Agenda Item #8

SUB-003069-2024 & ZON-UDC-003070-2024

RS Mobile Subdivision

APPLICATION NUMBER 8 DATE October 17, 2024	1,202
APPLICANT RS Mobile Subdivision	N
REQUESTSubdivision, Rezoning from R-1 and B-3 to B-3	\$
	NITC
	NTS

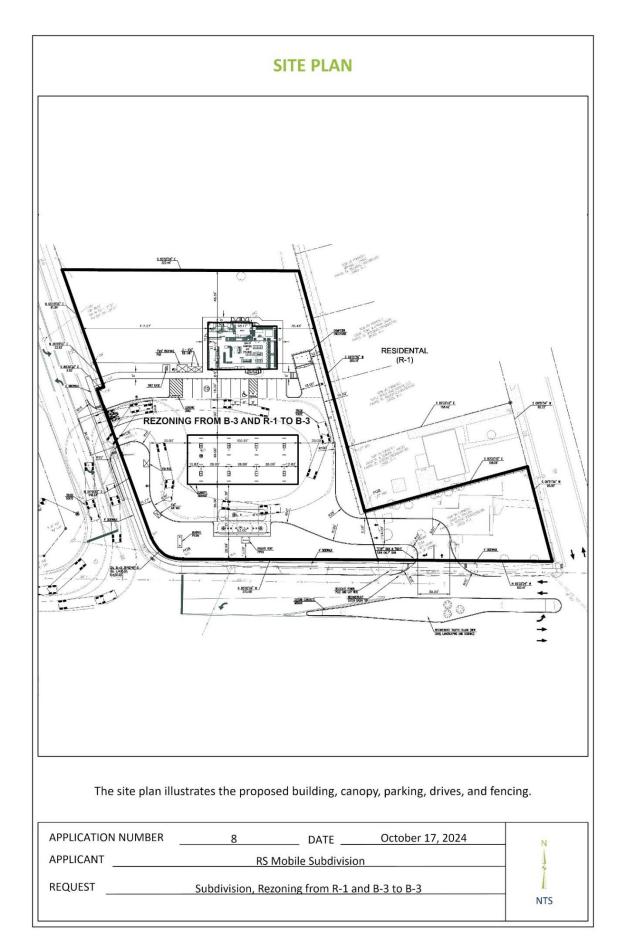
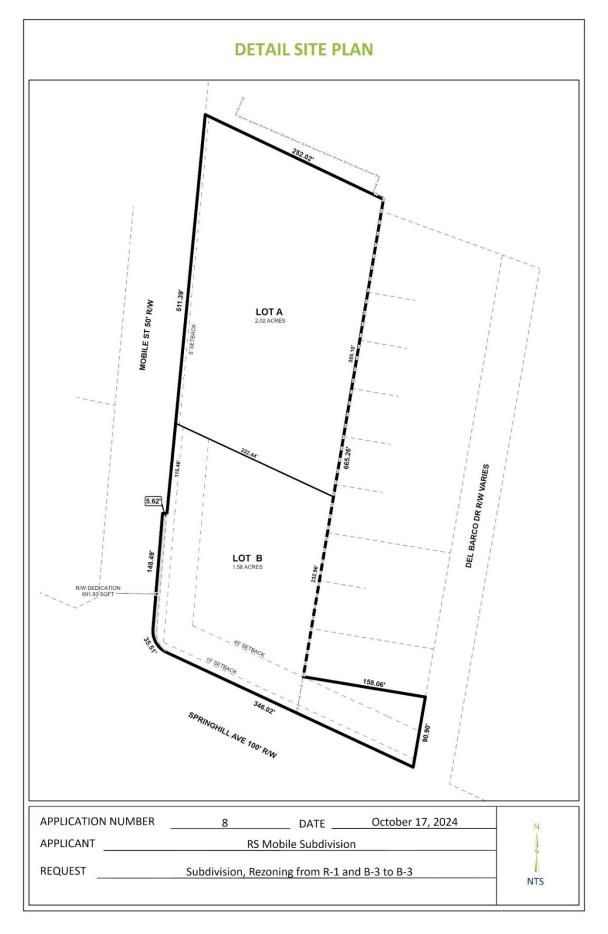
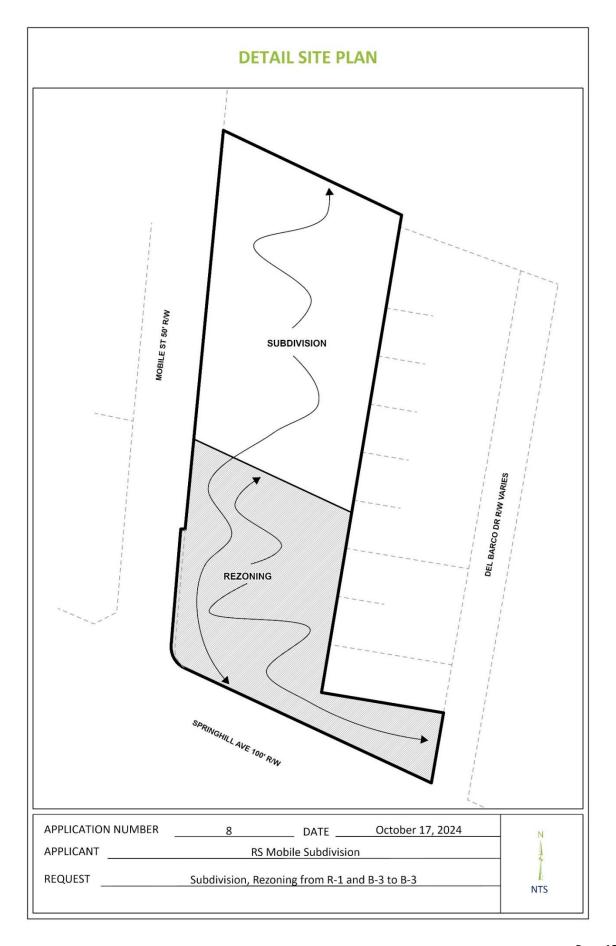
The applicant is proposing to create two (2) legal lots of record from three (3) metes-and-bounds parcels and an existing legal lot of record. Both proposed lots exceed the minimum required lot sizes, and if approved, the lot size information should be retained on the Final Plat in square feet and acres.

The applicant is proposing to combine a single legal lot of record, two (2) metes-and-bounds parcels, and a portion of a third parcel to create the proposed Lot B. The remainder of the third parcel is proposed to be Lot A. Lot A will remain zoned R-1, Single-Family Residential Urban District; whereas the proposed Lot B will be split-zoned, if approved as proposed, hence the accompanying rezoning application. If the Subdivision is approved, the rezoning must be finalized by the City Council prior to the signing of the Final Plat.

The subject site has frontage along Spring Hill Avenue, Mobile Street, and Del Barco Drive. Springhill Avenue, an ALDOT facility, and a planned major street as shown on the Major Street Plan Component of the Comprehensive Plan, requires a 100-foot right-of-way width. No additional right-of-way will be required along Springhill Avenue. Mobile Street is a proposed major street with curb and gutter that requires a right-of-way width of 80-feet; dedication to provide 40' from the centerline along Mobile Street should now be required, and is depicted on the preliminary plat. Del Barco Drive is a minor street with ribbon curb and gutters, and an existing 50-foot right-of-way, making no dedication necessary. As discussed in Traffic Engineering comments, if approved, a note should be placed on the Final Plat prohibiting Lot B from accessing Del Barco Drive.

Being that the subject site has frontage along Springhill Avenue, Mobile Street, and Del Barco Drive, the applicant must ensure that the property lines at the intersections provide a compliant curb radius. The Final Plat, if approved, should be revised to illustrate a dimensioned curb radius in compliance with Section 6.C.6. of the Subdivision Regulations.

As a proposed R-1 Urban lot, Lot A should have a five-foot (5') minimum front yard setback depicted along Mobile Street, if approved. As a proposed B-3 Urban lot, Lot B should have a ten-foot (10') minimum front yard setback and a 45-foot (45') maximum front yard setback depicted. The setbacks should be depicted after any right-of-way dedication on Mobile Street and the corner radii, if approved.

It should be noted that there is a legal description on the preliminary plat submitted, however it appears to contain errors and includes an adjacent property not depicted on the plat, or authorized to be part of the application. If approved, correct legal descriptions for both Lots A and B will be required.

- 1. Completion of the Rezoning process for proposed Lot B prior to signing the Final Plat;
- 2. Retention of the lot sizes in both square feet and acres, or the furnishing of a table on the Final Plat providing the same information, adjusted for dedication;

- 3. Dedication to provide 40-feet from the centerline along Mobile Street;
- 4. Dedication to provide a dimensioned curb radius in compliance with Section 6.C.6. of the Subdivision Regulations

- 5. Revision of right-of-way widths on the preliminary plat for dedication, as appropriate;
- 6. Retention of the 5-foot minimum building setback line along Mobile Street for Lot A, adjusted for dedication;

- 7. Revision of the plat to illustrate a 10-foot minimum building setback line along Mobile Street, Spring Hill Avenue, and Del Barco Drive for Lot B, adjusted for dedication;

- 8. Revision of the plat to illustrate a 45-foot maximum building setback line along Mobile Street, Spring Hill Avenue, and Del Barco Drive for Lot B, adjusted for dedication;

- 9. Provision of correct legal descriptions of both Lot A and Lot B;

- 10. Placement of a note on the plat stating that Lot B is prohibited from having direct access to Del Barco Drive;
- 11. Compliance with all Engineering comments noted in this staff report;
- 12. Placement of a note on the Final Plat stating all Traffic Engineering comments noted in this staff report;
- 13. Compliance with all Urban Forestry comments noted in this staff report; and,
- 14. Compliance with all Fire Department comments noted in this staff report.
